AQUIND INTERCONNECTOR

Applicant's Response to Second Information Request – ES Validity Review

Document Ref: 7.7.23

DATE: 16 SEPTEMBER 2021

DRAWING No: AQ-UK-DCO-TR-LAY-007 **REV:** E

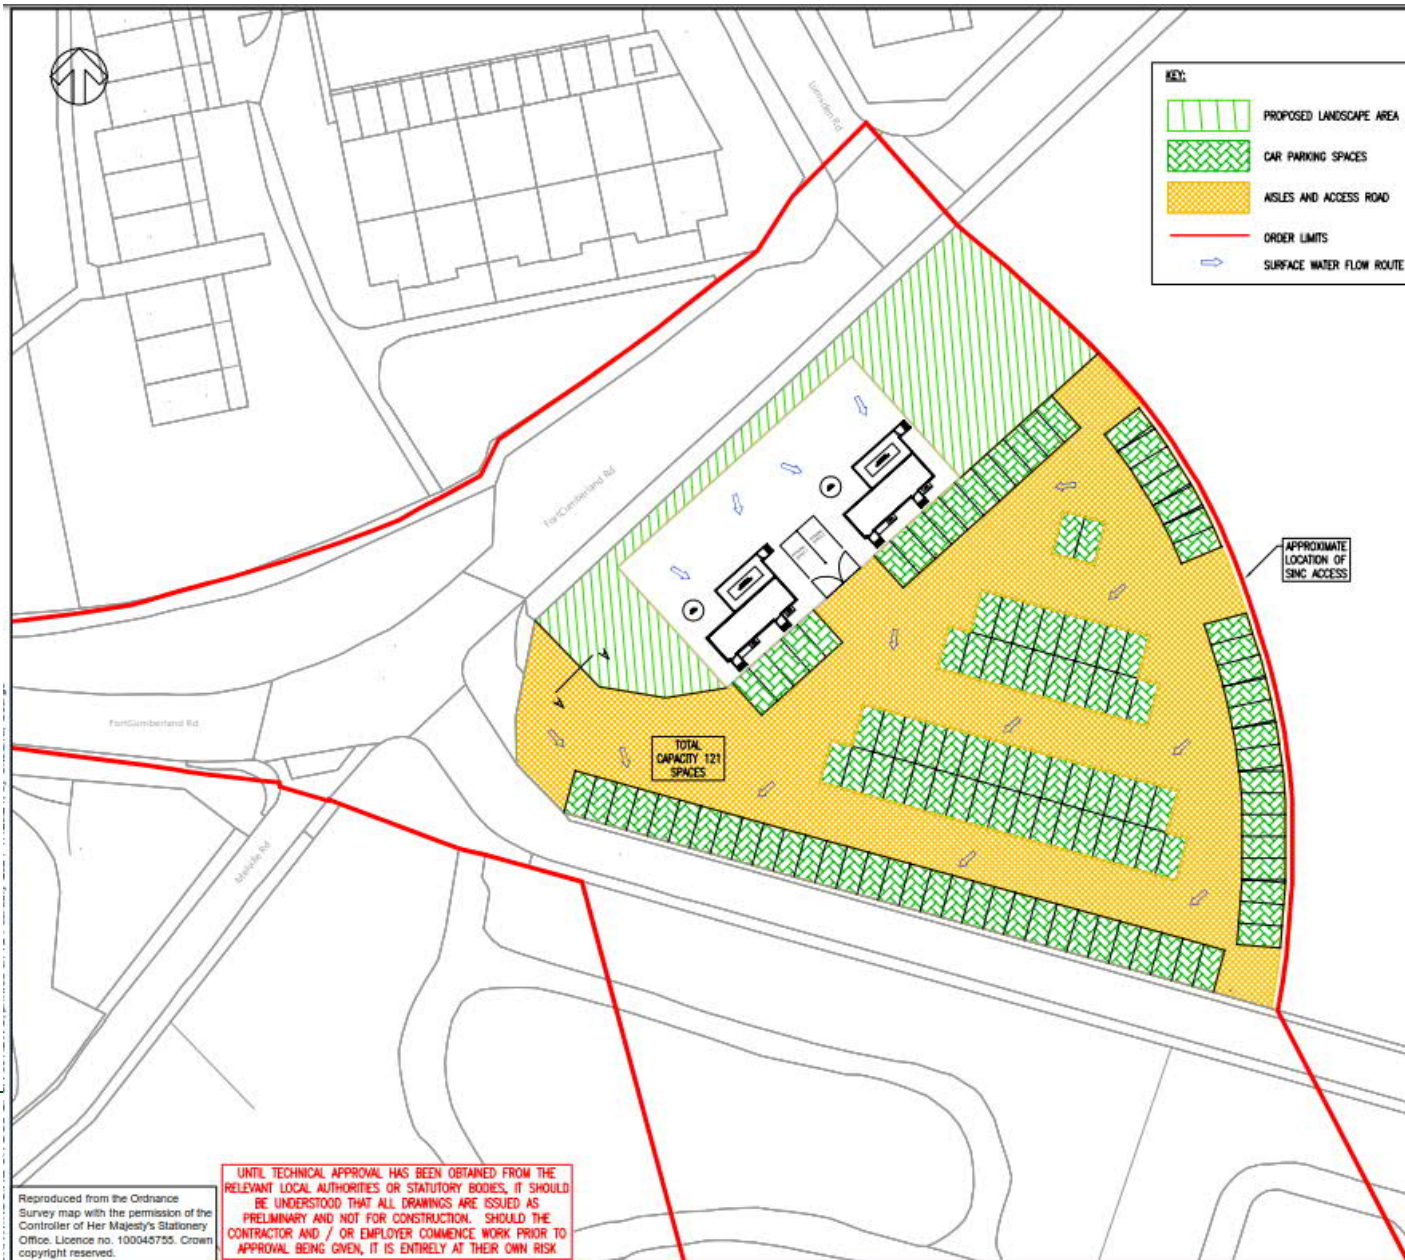
Document	Confirmation of whether ES remains valid and why
	<p>A slight increase in the number of parking spaces that could potentially be accommodated within the retained car park area at Fort Cumberland Car Park (subject to detailed design) whilst beneficial would be insufficient to require an assessment of the Operational Stage of the Proposed Development and therefore would not alter the level of significance of effects identified in the ES. As such, the findings and residual effects reported in Chapter 22 of the ES (APP-137) and Chapter 15 of the ES Addendum (REP1-139) remain unchanged and valid.</p> <p>Therefore, the assessment of traffic and transport impacts, as reported in section 22.6.14 of Chapter 22 (Traffic and Transport) of the ES (APP-137) and Chapter 15 of the ES Addendum (REP1-139) remains valid.</p>
<p>Chapter 23 Air Quality (REP1-033)</p>	<p>Regarding the reduction in size of the ORS buildings, the design includes the provision of backup power from two ≤200 kVA diesel powered generators which are sources of air emissions. The reduction in the output of the generators from 2 x 220kVA to 2 x 80kVA will reduce emissions.</p> <p>It should be noted that the assessment method applied EU Stage IV-Q emissions limit concentrations to represent the Aquind generators (220kVA) in the absence of manufacturer emissions specifications. The generators with lower output (80kVA) would fall under EU Stage IV-R for which are the same (except for carbon monoxide). Emissions are also likely to be lower than assessed because the generators procured (assuming after 2021) likely to meet more stringent emission EU Stage IV-R limits.</p> <p>Accordingly, air quality concentrations and impacts are likely to be lower than reported in section 23.6 of Chapter 23 (Air Quality) (REP1-033) and the conclusions of the ES remain unchanged and valid.</p>

REV	DATE	BY	DESCRIPTION	CHE	APP
F	10/08/2021	AM	UPDATED ORS BUILDING FOOTPRINT, LANDSCAPING AND INCREASED CAR PARK CAPACITY		
E	12/02/2021	HM	UPDATED AISLES AND ACCESS ROAD	0.8	0.8
D	11/02/2021	AM	UPDATED CAR PARK DESIGN WITH INCREASED CAPACITY	0.8	0.8
C	25/01/2021	AW	CAR PARK AISLES AND SPACES CONSTRUCTION INFORMATION ADDED	0.8	0.8
B	02/12/2020	AM	ADDITION OF APPROXIMATE SINC ACCESS LOCATION	0.7	0.8
A	02/12/2020	AM	FIRST ISSUE	0.7	0.8
